UNITED STATES PATENT AND TRADEMARK OFFICE

10/561,468

Office Action Summary	Application No. 10/561,468	Applicant(s) VAN EIBERGEN SANTHAGENS, ROBERT ALEXAND	
	Examiner JENNIFER SWINNEY	Art Unit 3724

DETAILED ACTION

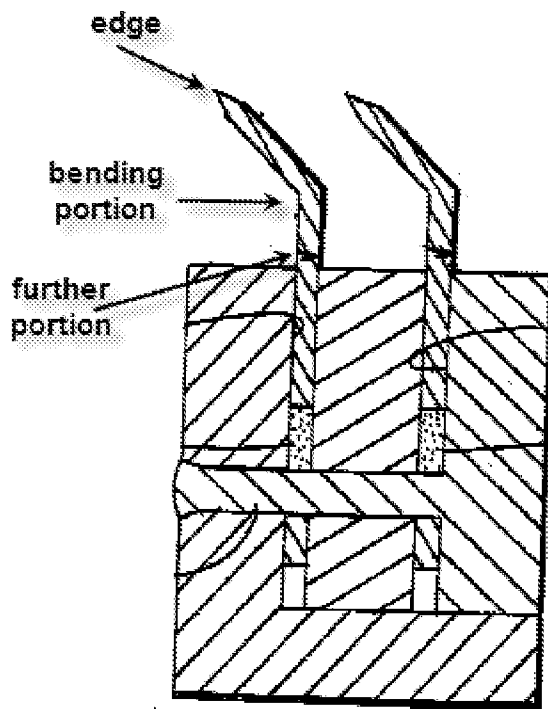
With respect to claim 1, Emmett discloses a razor head (it is old and well known in the art for a razor blades to be supported in a razor head) having one or more fixed bridge partitions (see figure 8) and at least one razor blade (302) attached to a corresponding fixed bridge partition of substantially equal length (see figure 8), each

blade comprising an edge portion with a cutting edge (306), a bending portion (see figure 8, below) positioned between the edge and the further portions, where the edge portion is bent relative to the further portion (see figures 7 and 8) and spaced from said cutting edge and the fixed bridge partition (see figure 8).

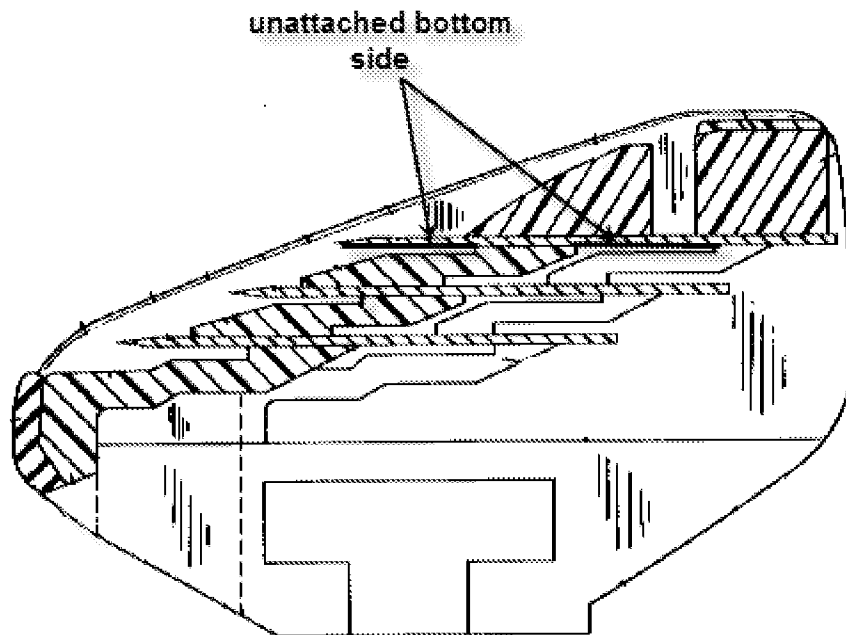
Ferraro discloses a top side of a blade (Fig. 3, 40,50,60) attached to a bridge partition (Fig. 3, 80,80a) of a razor head, and an unattached bottom side (Fig. 3, see below). It would have been obvious to one having ordinary skill in the art at the time of invention to provide Emmett with a bridge partition as taught by Ferraro. It is old and well known to provide a bridge partition between blade members of a razor head to provide additional structural support. The bridge partition is also capable of serving as a protective guard as the blade engages the skin, creating a smoother shaving process.
